# Technical Evaluation Report

Draft Waste Incidental to Reprocessing  
Evaluation for Vitrified Low-Activity  
Waste Disposed Onsite at the  
Hanford Site, Washington

## Final Report

U.S. Nuclear Regulatory Commission  
Office of Nuclear Material Safety and Safeguards  
Washington, DC 20555-0001

**Figure 4-5 Vertical Cross Sections of Engineered Features Represented in Performance Modeling of the IDF**  
 [Figure 2-3 of (RPP-CALC-61029, 2017)]

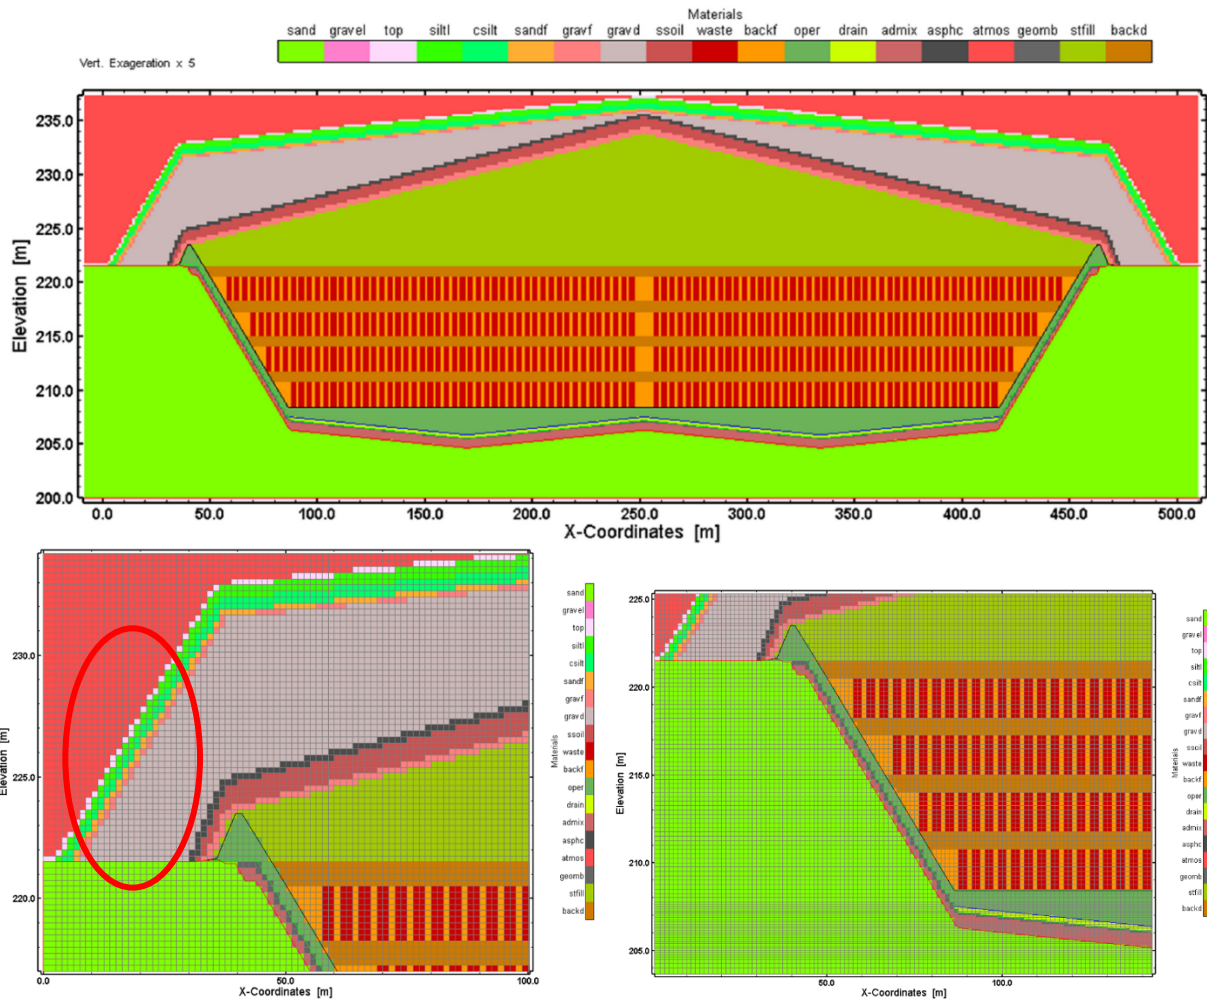
domain that DOE needed to simulate was quite large (thousands of cubic meters), whereas some of the material layers are designed to be quite thin (scale of centimeters). As shown in Figure 4-5, the discretization of some of the layers in the numerical model was not continuous (shown outlined in red oval).

DOE acknowledged the discontinuities in the layers in the model but stated that the near-field hydrology modeling was used to define boundary conditions for the wasteform release and transport modeling. The near-field flow model was used to develop estimates of saturations in the backfill and wasteforms in the absence of long-term data and to evaluate the distribution of moisture movement into the vadose zone in the presence of an intact and a degraded liner system. The NRC staff believes it is unlikely that the artifacts DOE introduced by the discretization of the surface barrier significantly impacted the boundary conditions for the wasteform release modeling. The distance from the modeling artifacts in moisture distributions and flow to the waste is generally many meters, allowing time/space for the artifacts to be reduced. The amount of water reaching the glass wasteform and the amount of water flowing through the cracked glass wasteform were substantially different. If the magnitude of the diversion of water was sensitive to the boundary conditions, then the discontinuities in the overlying layers could be significant. It is recommended that DOE evaluate if the numerical grid used was sufficient and eliminate numerical modeling artifacts to the extent possible in future evaluations (Recommendation #4).

**Figure 4-11 Partitioning of Select Volatile Radionuclides Among Wasteforms for Different Inventory Cases**

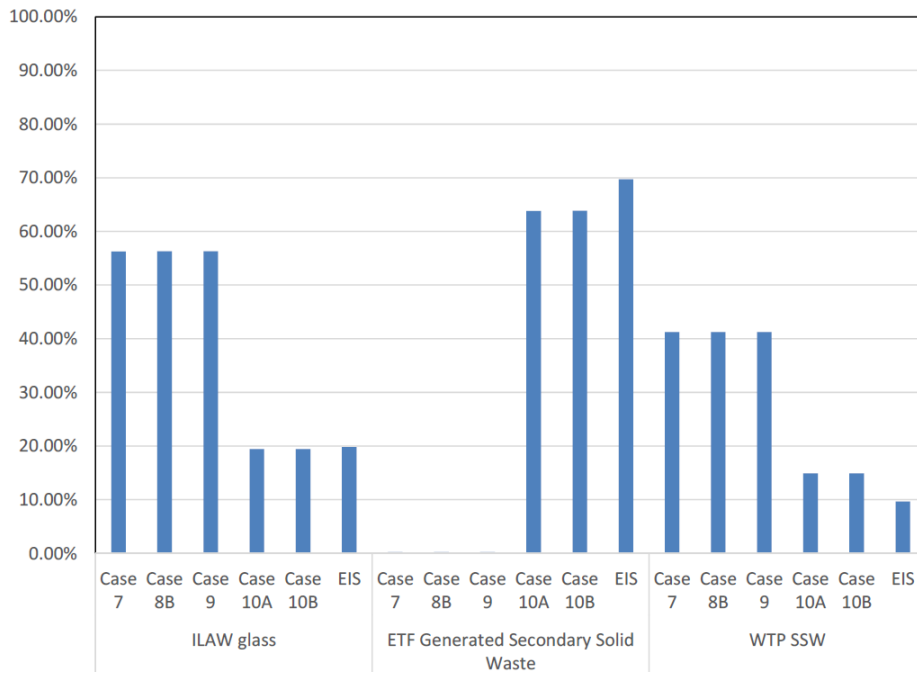
DOE identified the amount of volatile species that partition between different wasteforms (i.e., glass or non-glass) as a key uncertainty. The NRC staff agrees that the partitioning of volatile species between wasteform types is a key uncertainty. In the IDF PA, DOE evaluated different inventory cases. Figure 4-11 shows the disposition of two volatile radionuclides ( $^{99}\text{Tc}$  and  $^{129}\text{I}$ ) for the different inventory cases. DOE stated that the inventory cases produced small doses in the 1,000-year compliance period (well below the performance objective). However, peak doses from options 10a and 10b were much higher than other alternatives and exceeded the performance objective in the sensitivity and uncertainty analysis period. Doses from Case 7b were also higher than the remaining cases and were close to the 0.25 mSv/yr (25 mrem/yr) protection of the public performance objective in the sensitivity and uncertainty analysis period.
